**LAND USE APPLICATION SUMMARY**

*Property Location:* 828 Kasota Ave SE  
*Project Name:* New French Bakery Addition  
*Prepared By:* Shanna Sether, Senior City Planner, (612) 673-2307  
*Applicant:* New French Bakery  
*Project Contact:* Rob Duffy  
*Request:* To allow for an addition to an existing warehouse, wholesale and distribution use.

<b>Site Plan Review</b>	For a 2,400 sq. ft. addition to an existing warehouse, wholesale and distribution use.
-------------------------	--

1 LANDSCAPE PLAN

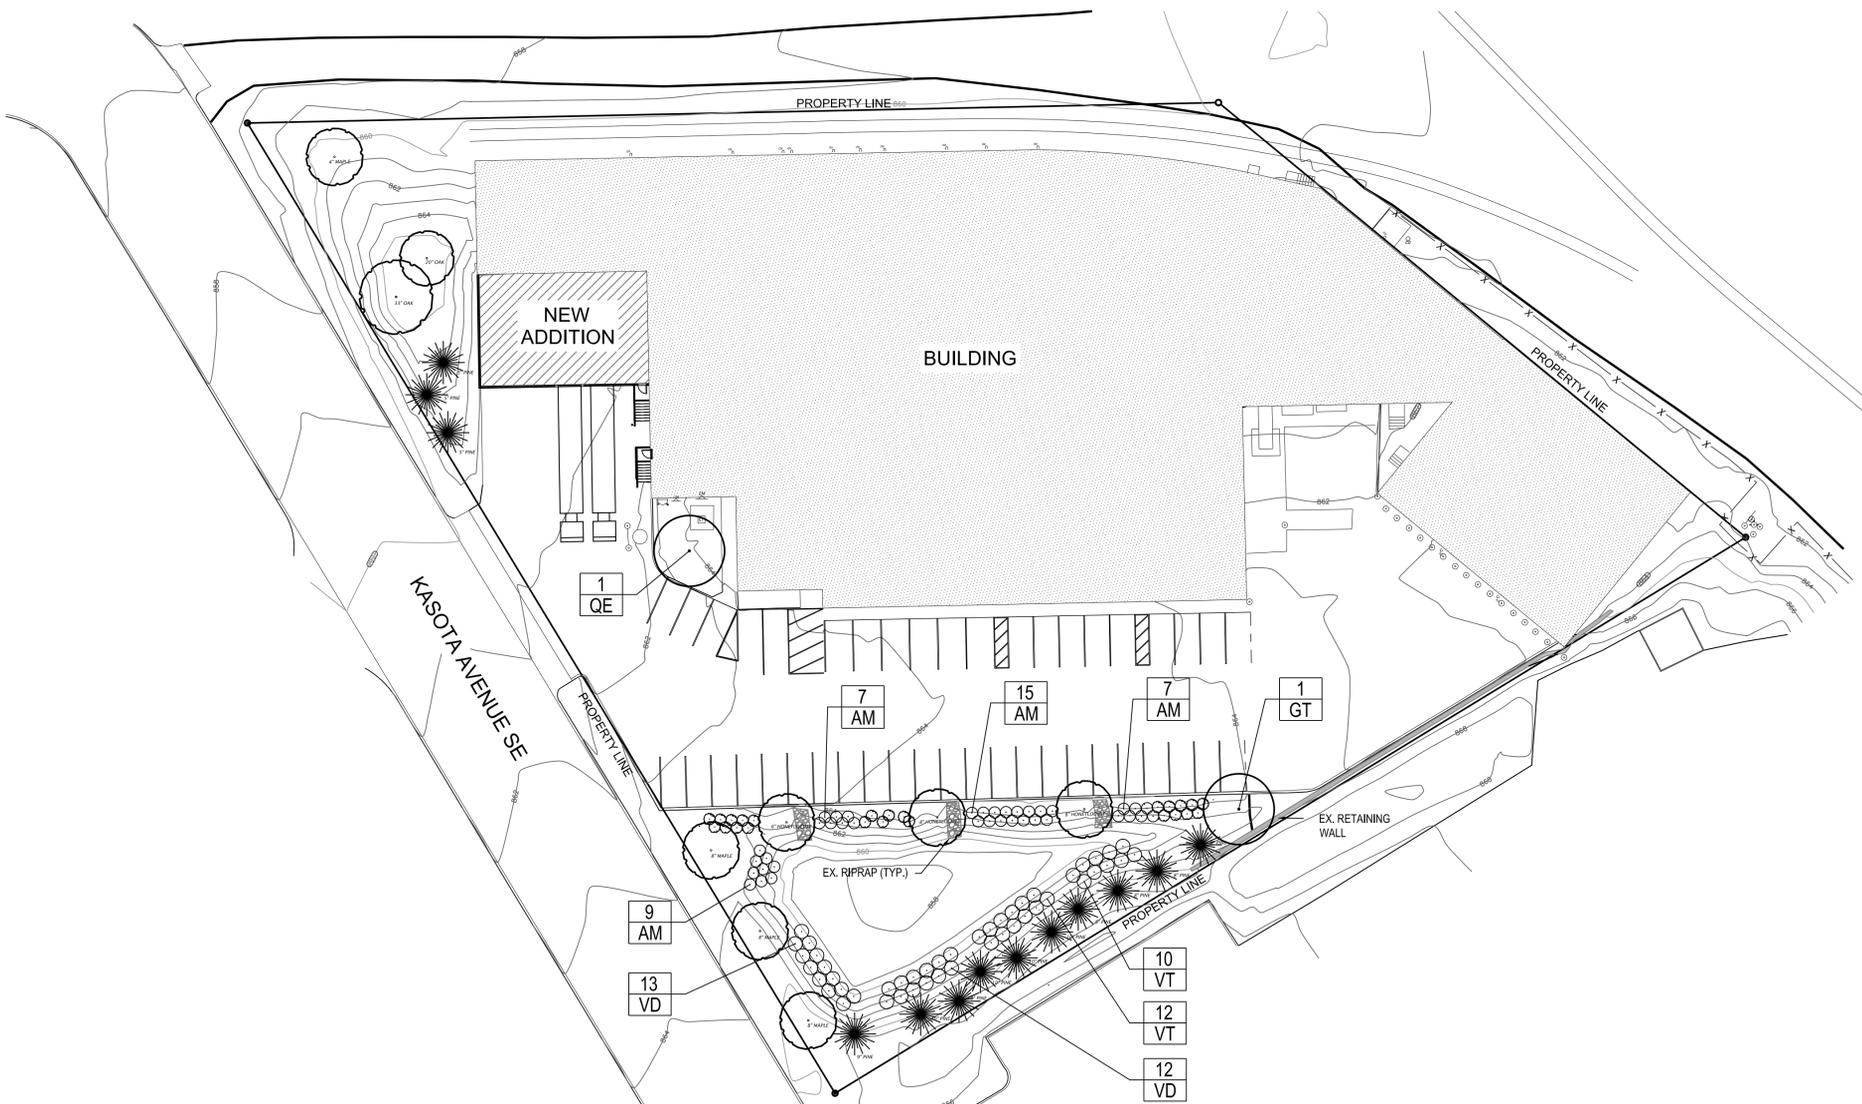
- The applicant has an approved site plan that shows twelve Toutonii Yews, located in the right-of-way, intended to screen the parking lot. The shrubs were planted; however, they do not appear to be more than 2 ft. in height. Staff is recommending that the applicant provide additional shrubs, at least three feet in height, to screen the existing parking area from the public street.

- There is at least one tree provided for each 25 linear feet, or fraction thereof, of parking or loading area frontage.
- The corner of the parking lot that is unavailable for parking or vehicular circulation at the SW corner of the property is recommended by staff to be landscaped.

- **Parking area screening.**
  - The applicant has an approved site plan that shows twelve Totonii Yews, located in the right-of-way, intended to screen the parking lot. The shrubs were planted; however, they do not appear to be more than 2 ft. in height. Staff is recommending that the applicant provide additional shrubs, at least three feet in height, to screen the existing parking area from the public street.

- **Loading area screening.** The site contains a parking and loading area for trucks or commercial vehicles more than 15,000 pounds. The existing loading area is screened with a combination of a berm and three conifers. The proposed addition will be more visible than the existing building as the berm lowers in height to less than 6 ft. For this area, the staff is recommending screening six feet in height and 90 percent opaque consisting of a hedge.

1. All site improvements shall be completed by August 29, 2018, unless extended by the Zoning Administrator, or the permit may be revoked for non-compliance.
2. CPED staff shall review and approve the final site, elevation, landscaping, and lighting plans before building permits may be issued.
3. The plant materials, and installation and maintenance of the plant materials, shall comply with sections 530.200 and 530.210 of the zoning code.
4. The applicant shall provide additional shrubs, at least 3 feet in height, to help screen the southwest corner of the parking lot.
5. The applicant shall provide an a six-foot screen consisting of a hedge that is at least 60 percent opaque between the proposed addition and Kasota Ave SE to screen the proposed loading area.
